**Filename:** S04-0138-008

**Application firmware revision:** 20.0

**Models affected:** All

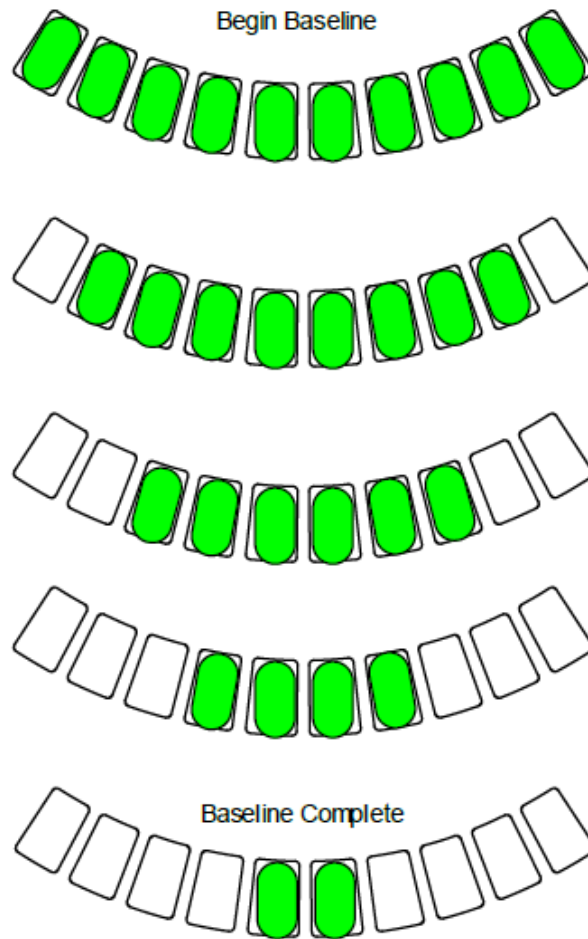
The user interface has been updated to indicate the amount of time remaining during airflow baselining.

If the system has not been baselined or a baseline reset has been initiated the device will illuminate all 10 segments on the airflow graph. As the baseline period progresses the segments will gradually turn off starting from the outside until it reaches the two center segments indicating the device has completed baselining. The baselining period is approximately 5 minutes.

If the device was previously baselined then the two center segments on the airflow graph will blink during the power on initialization period. The power on initialization period is approximately 5 minutes.
